**Sauk County Landfill Site,
Excelsior, WI,
3/24/1994**

PROPOSED RECORD OF DECISION

REMEDIAL ACTION FOR THE SOURCE CONTROL OPERABLE UNIT

Fig. 1

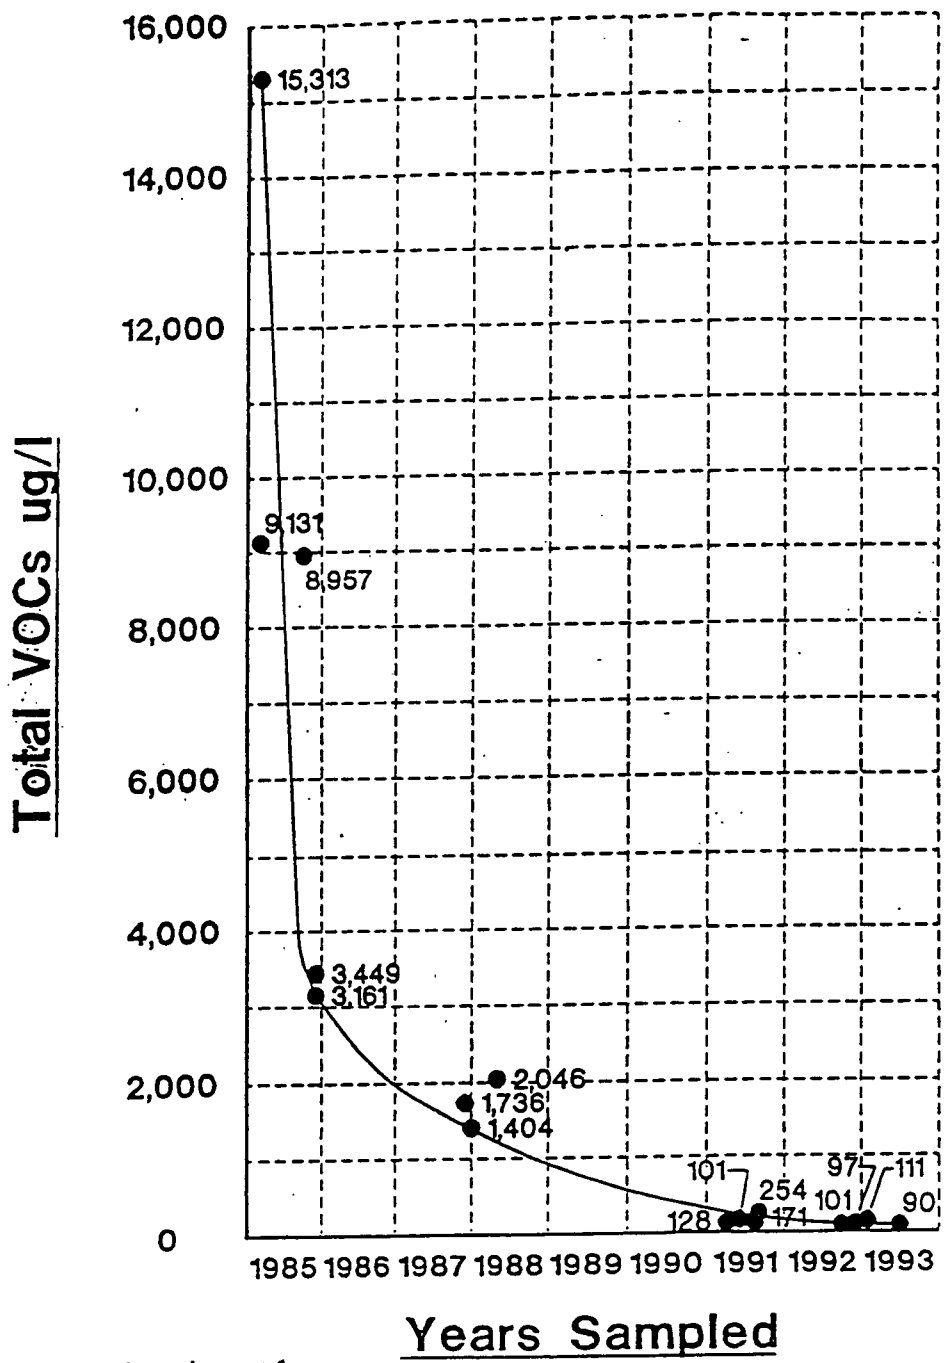
1. Sauk County presented groundwater quality data from TW-25 and TW-26A. Both of these wells have historical VOC data dating back to 1985 and 1987 respectively. When the entire total VOC data set is graphed as concentration vs. time, both data sets indicate a strong downward trend in the VOC concentrations. Capping is the only remedial action that has taken place on the landfill since closure in 1983. Thus, the cap that is on the site is having beneficial effects towards stopping the further release of contaminants to groundwater. The data from TW-25 and TW-26A are depicted on Figures 1 and 2, respectively.

2. Sauk County commented that the decrease in total VOCs at TW-25 and TW-26A can be explained using the exponential decay equation. This equation assumes that the source decays at a constant rate. Decay rates are often measured in half-lives, or the amount of time necessary for the concentration to decay (or decrease) to one-half of it's original concentration. The analysis presented by Simon Hydro-Search indicates that:

WDNR agrees that VOC concentrations in groundwater are decreasing and exponential decay is probably playing a part in the decrease. However, other factors such as minimizing inputs to groundwater and dilution are also contributing to the decreasing VOC concentrations.

Fig. 3

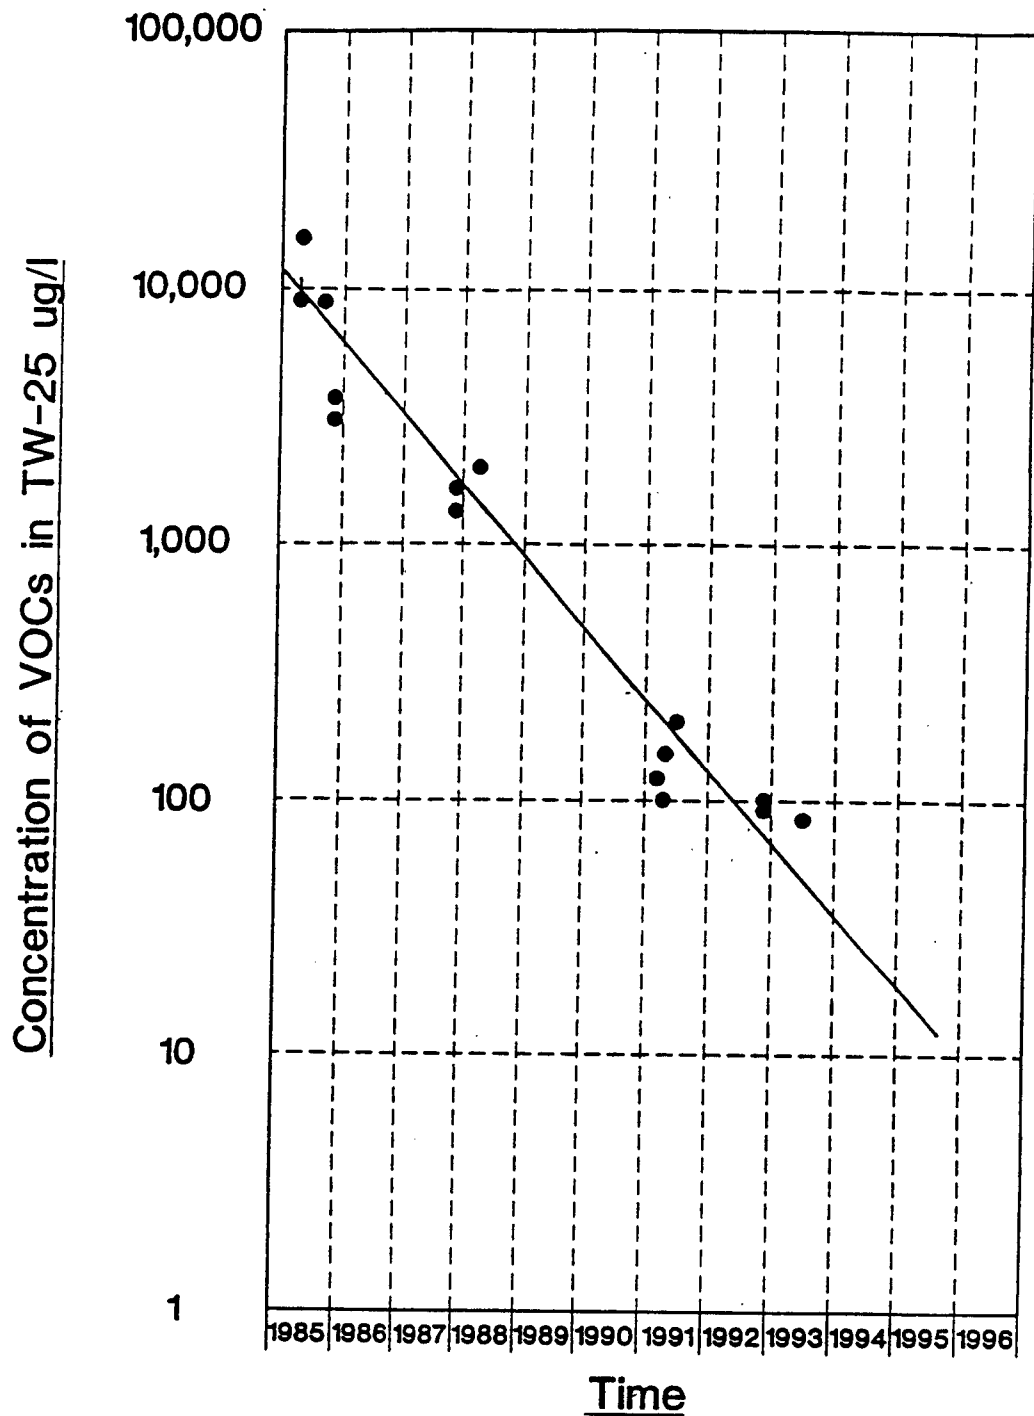
- * the half-life based upon data from TW-25 and TW-26A are the same and are approximately 1 year
 - * the semi-log graph of data vs time has a straight line for both wells. This indicates the decay rate is constant and that there is not additional input of VOCs from the landfill.

- * a comparison of the two semi-log graphs shows that they have similar slopes. This indicates that the same process of releasing

VOCs from the aquifer matrix is occurring at both locations. See Figures 3 and 4.

Fig. 5

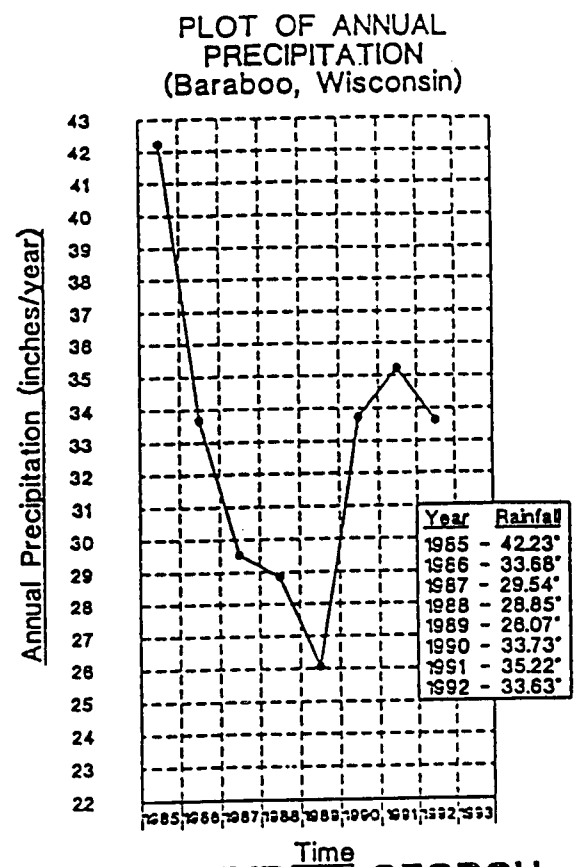
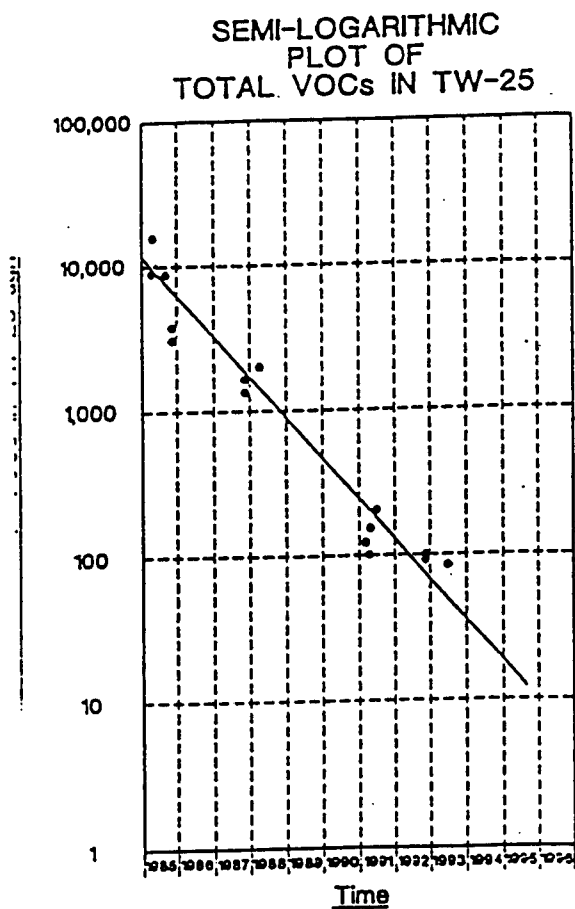
3. A graph comparing total VOC concentrations at TW-25 and the precipitation at Baraboo indicates that high precipitation years don't produce flushing events from the landfill. This means that the existing landfill cap has been successful in reducing percolation of water into the landfill. See Figure 5.
